REVISED
07.08.2015

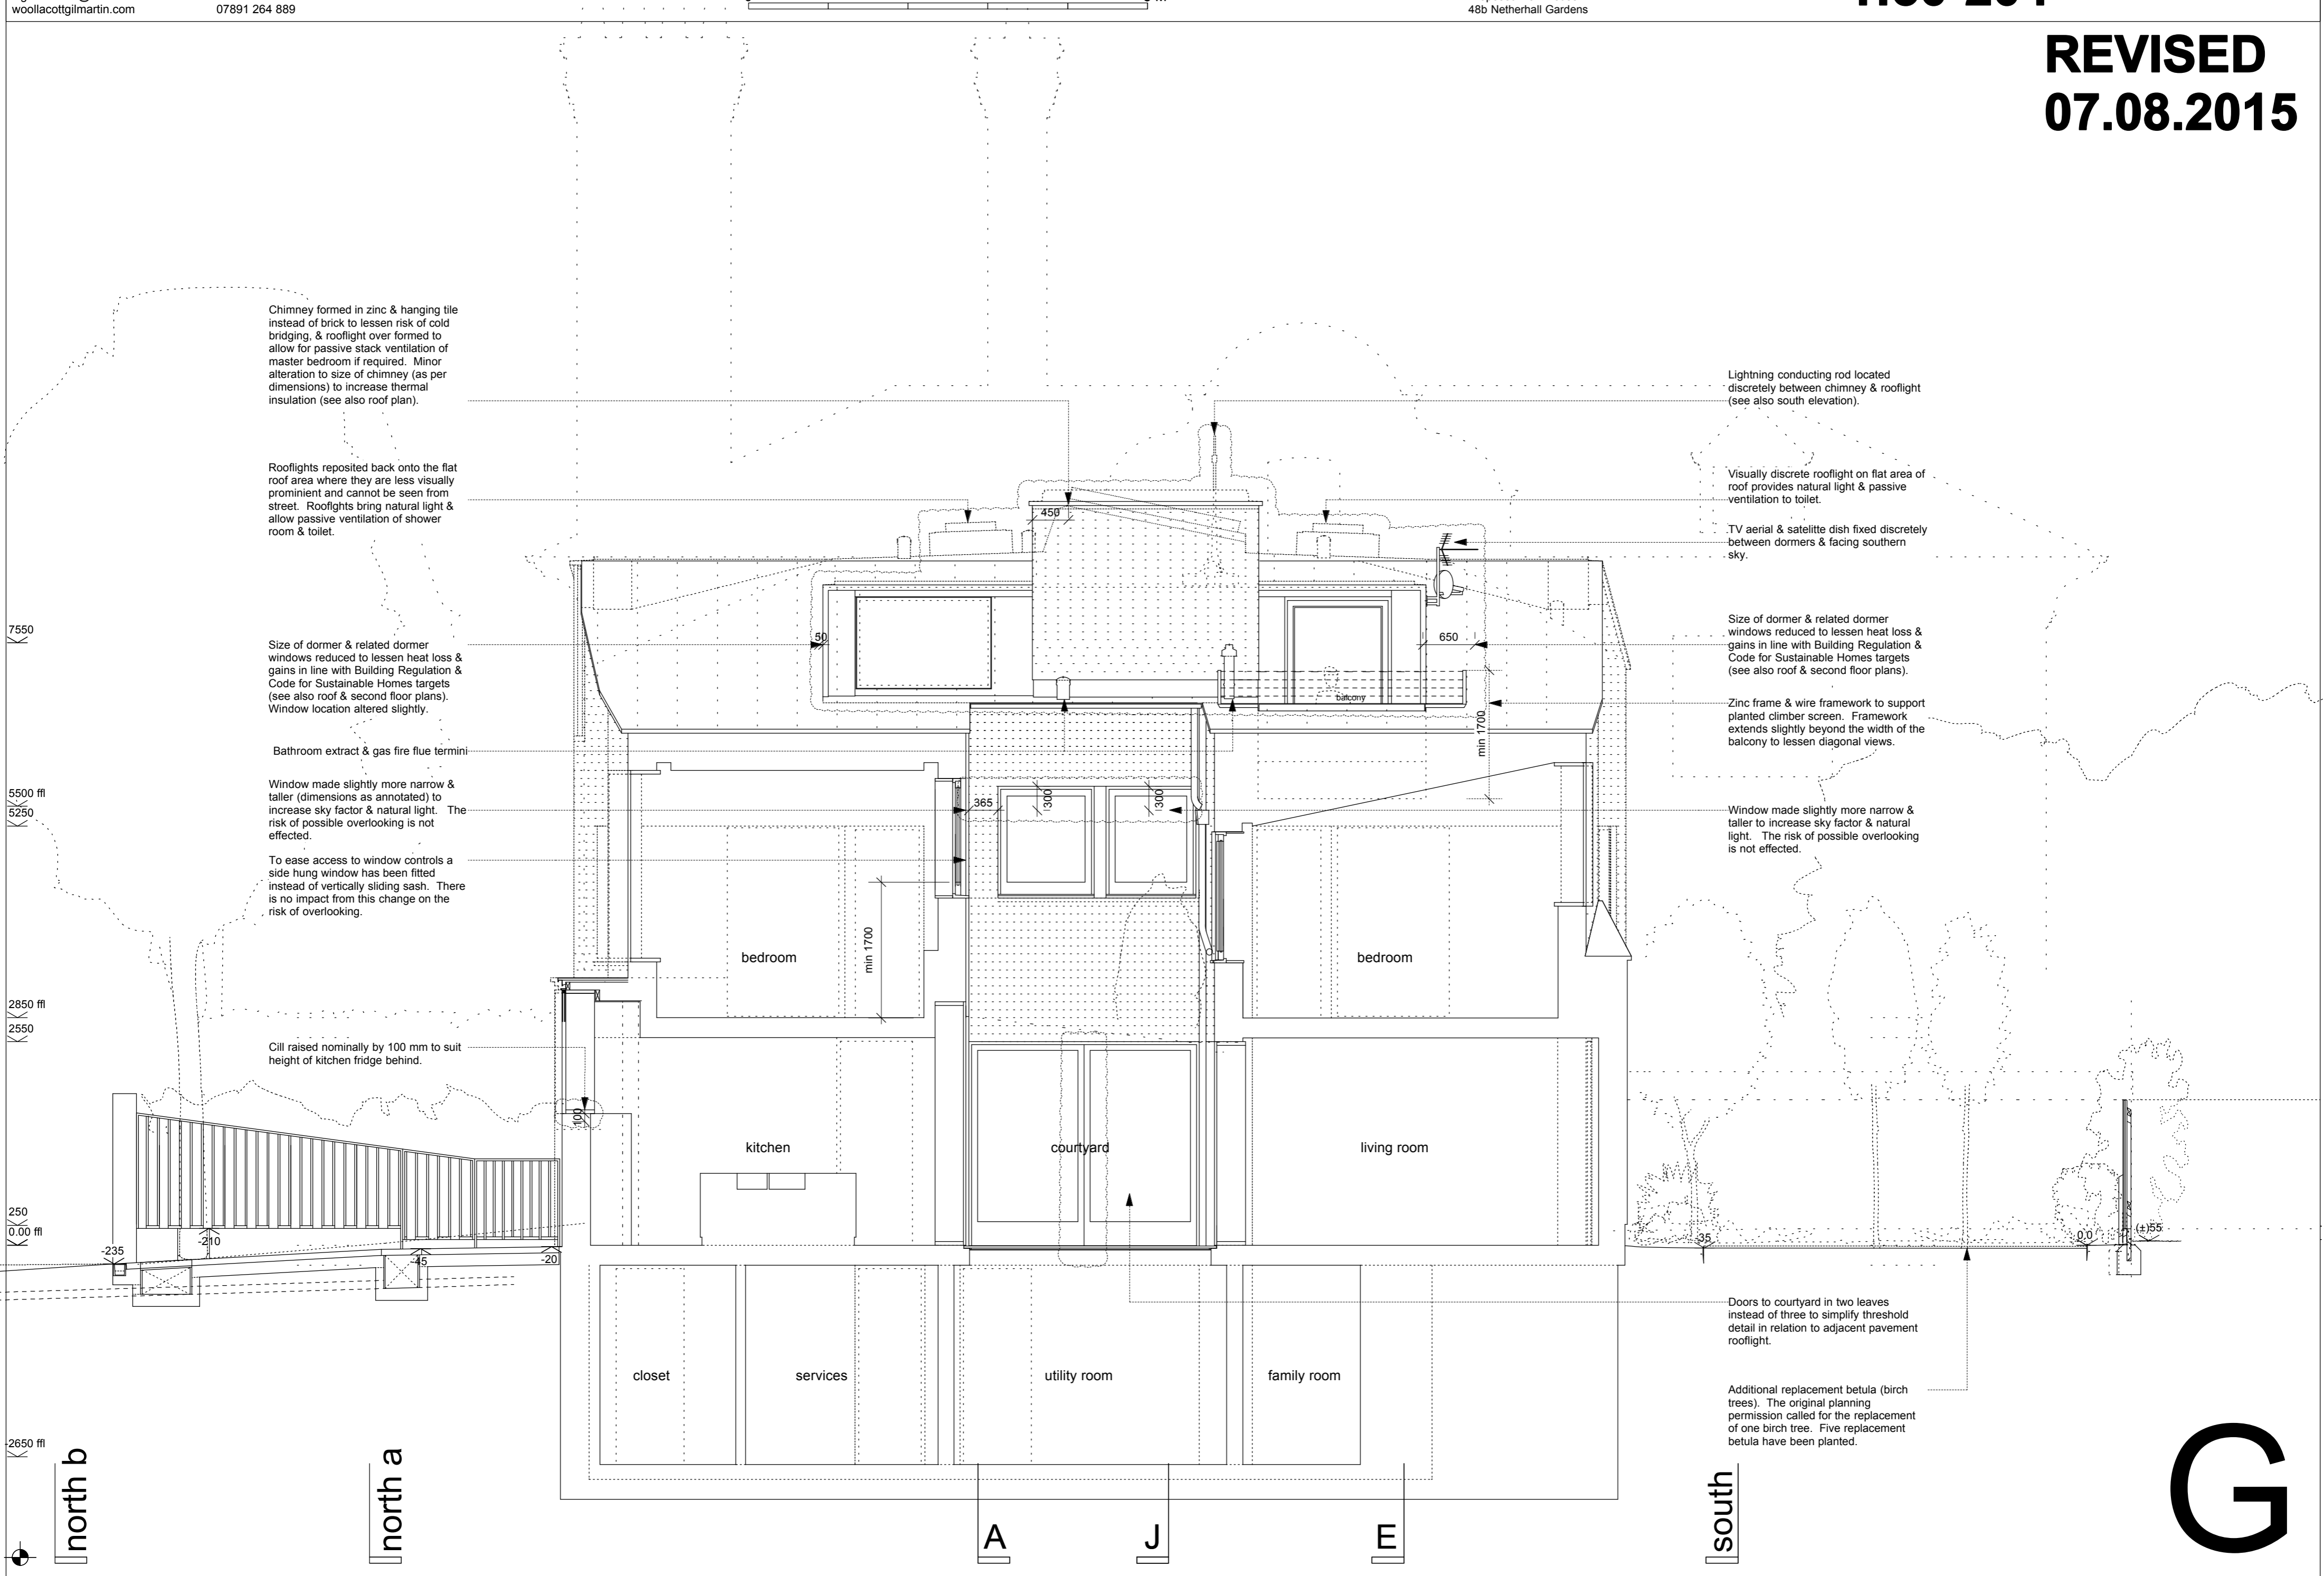
Chimney formed in zinc & hanging tile instead of brick to lessen risk of cold bridging, & rooflight over formed to allow for passive stack ventilation of master bedroom if required. Minor alteration to size of chimney (as per dimensions) to increase thermal insulation (see also roof plan).

Rooflights repositioned back onto the flat roof area where they are less visually prominent and cannot be seen from street. Rooflights bring natural light & allow passive ventilation of shower room & toilet.

Size of dormer & related dormer windows reduced to lessen heat loss & gains in line with Building Regulation & Code for Sustainable Homes targets (see also roof & second floor plans). Window location altered slightly.

Bathroom extract & gas fire flue termini

Window made slightly more narrow & taller (dimensions as annotated) to increase sky factor & natural light. The risk of possible overlooking is not effected.

To ease access to window controls a side hung window has been fitted instead of vertically sliding sash. There is no impact from this change on the risk of overlooking.

Cill raised nominally by 100 mm to suit height of kitchen fridge behind.

Lightning conducting rod located discretely between chimney & rooflight (see also south elevation).

Visually discrete rooflight on flat area of roof provides natural light & passive ventilation to toilet.

TV aerial & satellite dish fixed discretely between dormers & facing southern sky.

Size of dormer & related dormer windows reduced to lessen heat loss & gains in line with Building Regulation & Code for Sustainable Homes targets (see also roof & second floor plans).

Zinc frame & wire framework to support planted climber screen. Framework extends slightly beyond the width of the balcony to lessen diagonal views.

Window made slightly more narrow & taller to increase sky factor & natural light. The risk of possible overlooking is not effected.

Doors to courtyard in two leaves instead of three to simplify threshold detail in relation to adjacent pavement rooflight.

Additional replacement betula (birch trees). The original planning permission called for the replacement of one birch tree. Five replacement betula have been planted.
